**Groundwater Levels in Mines and Wells on 6-24-09
as Reported in DEIS Table III.C.1 plus Hotel Mine**

Groundwater Level Figure

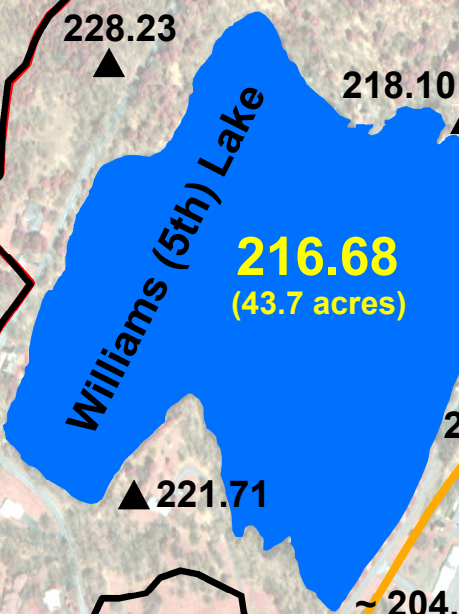
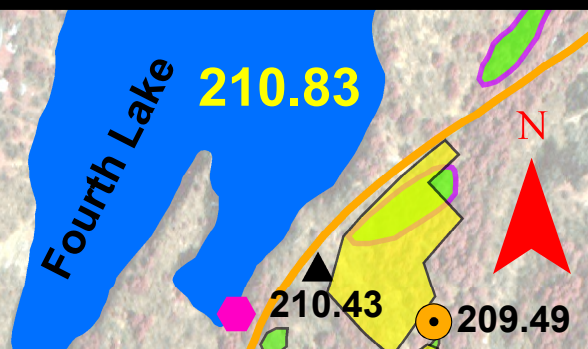
The Williams Lake watershed area, as determined by HRVR (black polygon), does not factor in either karstic or mining-related groundwater flow that does not and cannot recharge the lake. As a result, the groundwater basin that contributes flow to Williams Lake is much smaller - making the recharge area to the lake (minus the lake acreage) at least 36 percent less than reported. Beyond this, HRVR has NOT depicted MAJOR mine footprints and sinkholes that SUBSTANTIALLY alter the flow dynamics indicated by HRVR. As shown here, groundwater in much of the HRVR basin would have to flow uphill as much as 17 ft to flow into Williams Lake. Thus, all model-derived conclusions are erroneous. There is substantial doubt as to whether there is sufficient water for the proposed project.

Elongate vertical mine may extend over 100 ft below rubble base and does control groundwater flow in parts of the watershed, probably to the NE out of the watershed. Sinkhole conduits may also shunt water out of the watershed - resulting in a smaller watershed than put forth in the DEIS.
